REVISED RESPONSE TO REQUEST FOR ADDITIONAL INFORMATION

APR1400 Design Certification

Docket No. 52-046

RAI No.: 253-8300
SRP Section: 03.07.01 – Seismic Design Parameters
Application Section: 3.7.1
Date of RAI Issue: 10/19/2015

Figure 11: Comparison of Transfer Function for NI, EDGB and DFOT, S06 Case, E-W Direction

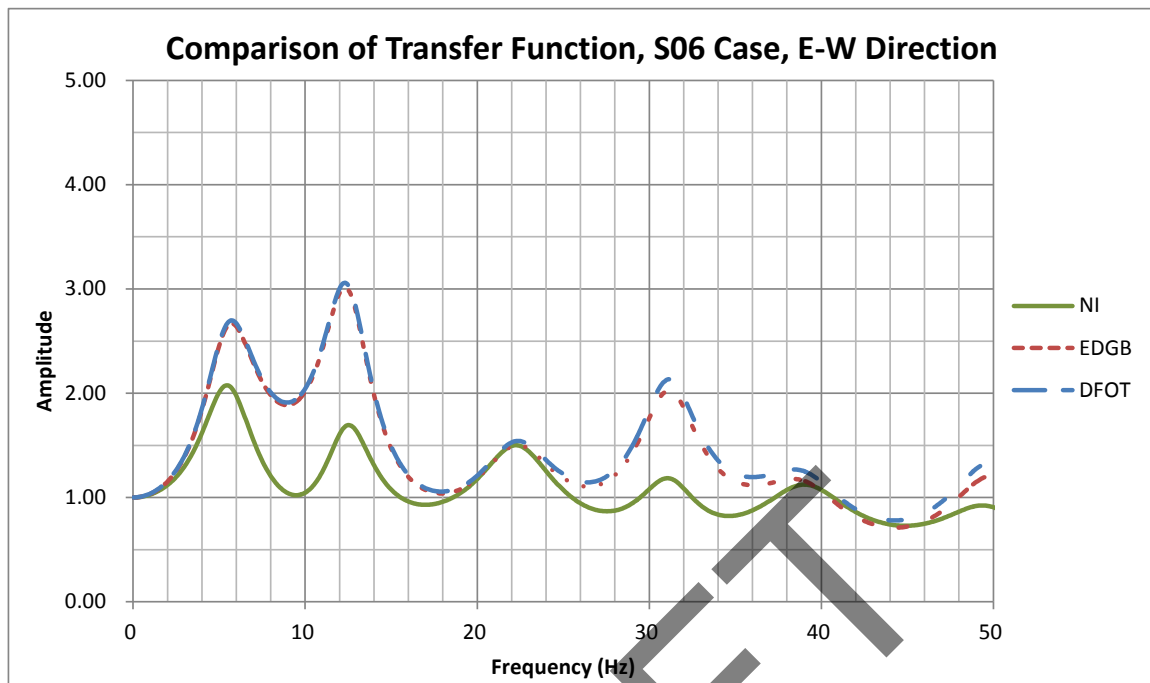
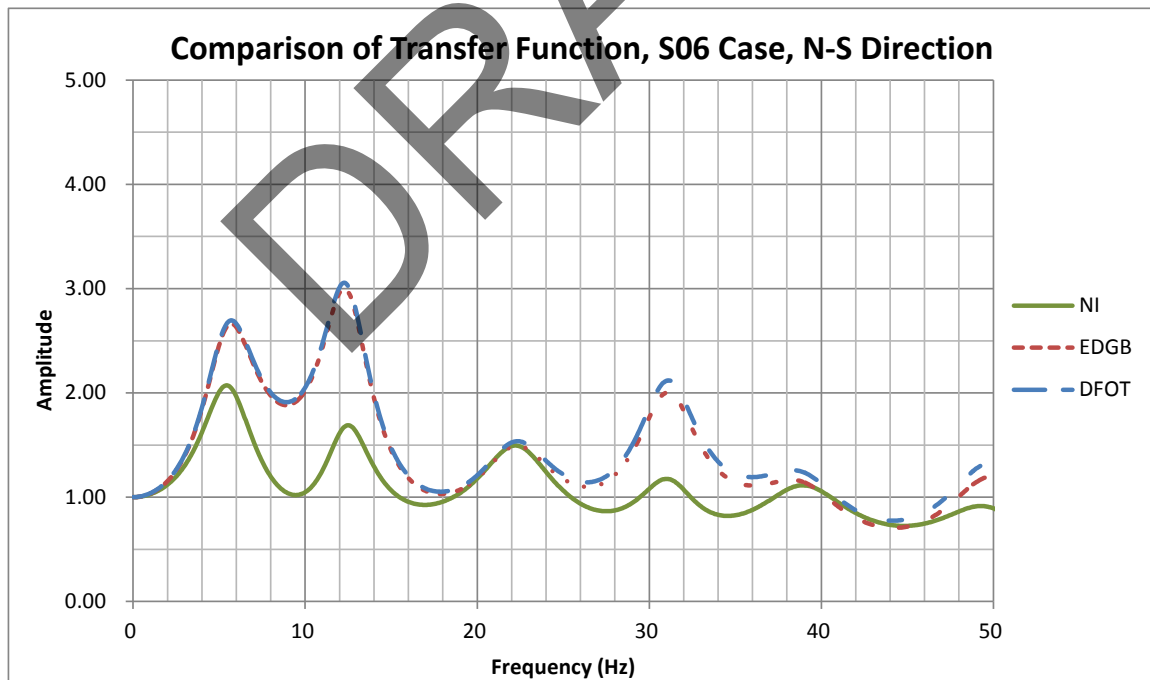
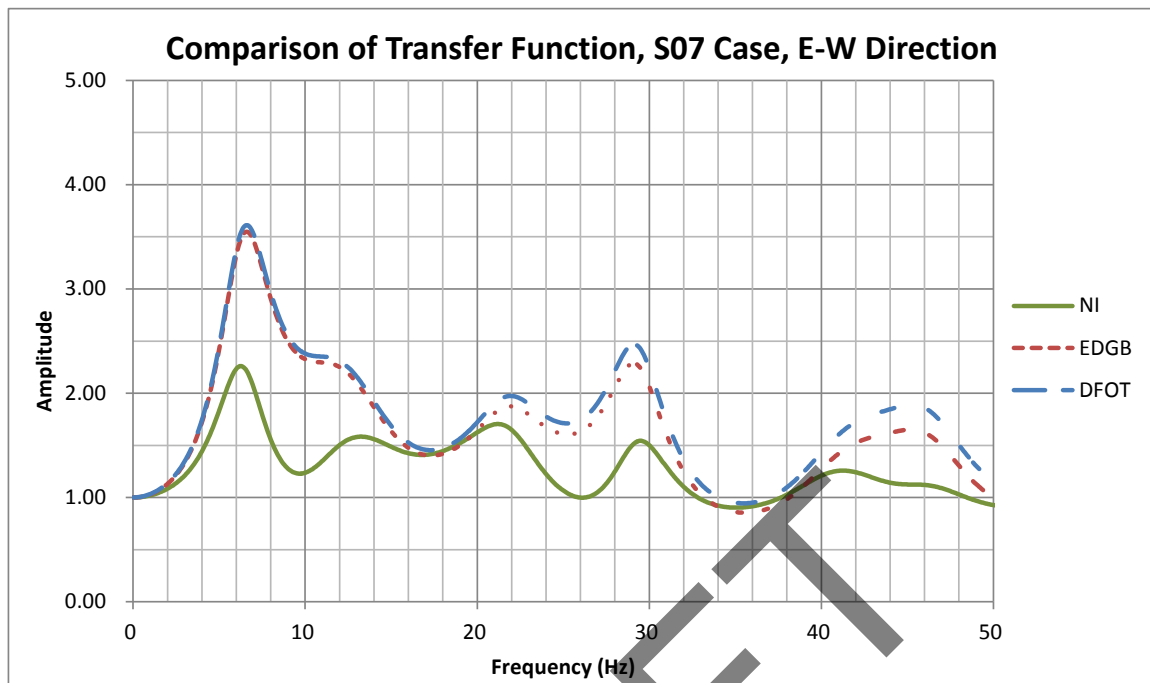
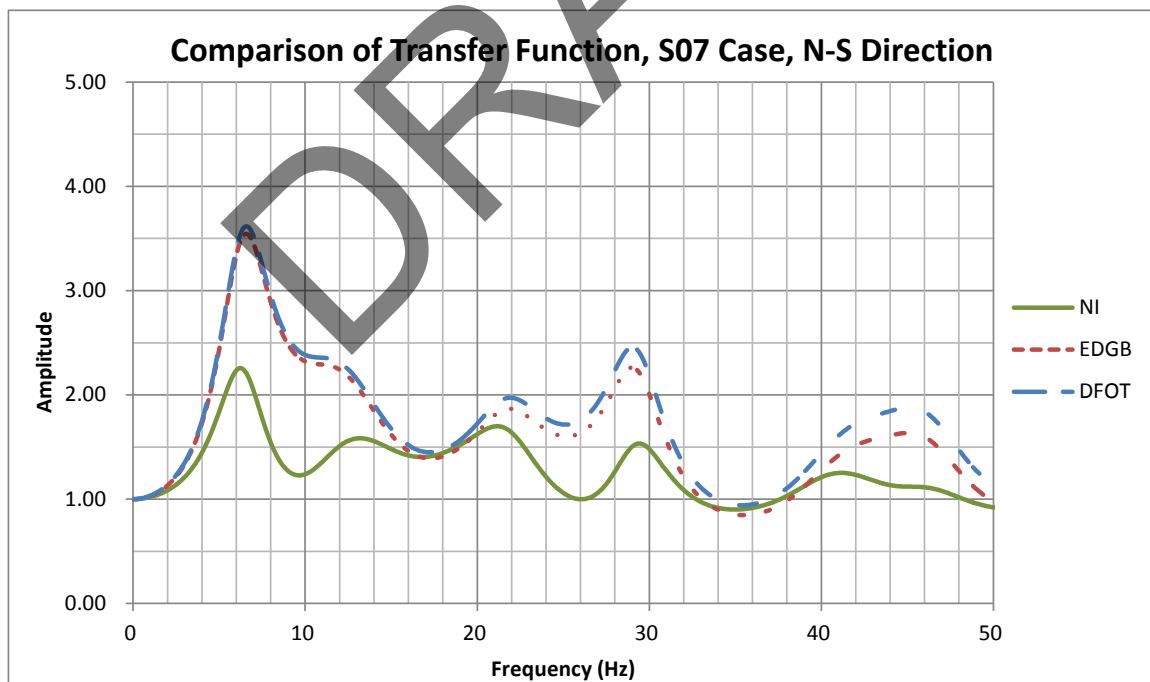
Figures 5-25 and 5-26 of APR1400-E-S-NR-14001-P, Rev. 0 show that the $CSDRS_{ff}$ in the horizontal directions for soil profiles S6 and S7 appear to be significantly different from the other soil cases for the NI structure. Figure 5-27 shows that the $CSDRS_{ff}$ in the vertical direction for these two soil cases are also different but not as significant. The variation in the strain-compatible soil profiles among the 9 layered soil profiles are gradual, as shown in Figures 5-14 through 5-22, and as shown by the approximately linear behavior of the soil fundamental frequency on a log scale in Figure 5-24. The transfer functions shown in Figure 5-23 also indicate that amplification effect occurs at various frequency points below 50 Hz for all soil cases. It is not obvious to the staff why only $CSDRS_{ff}$ for S6 and S7 show the large dips as shown in Figures 5-25 and 5-26 and why other soil profiles for the NI structure (and all soil cases for EDGB and DFOT) do not show any dips at their fundamental frequencies. The applicant is requested to explain in detail (1) the method to calculate the $CSDRS_{ff}$ and (2) why soil cases S6 and S7 for the NI behave differently from the remaining soil cases, and if the results presented in the technical report are not accurate, to include the corrected results for all soil cases, for all 3 structures.

The large dips for the S6 and S7 soil cases for the NI are due to the specific site layering configurations and site properties of the S6 and S7 profiles. These large dips are reflected in the site response transfer functions of the motions at the FIRS elevations of the NI structures, DFOT, and EDGB relative to their corresponding free-field surface motions, as indicated in Figures 1 through 18.
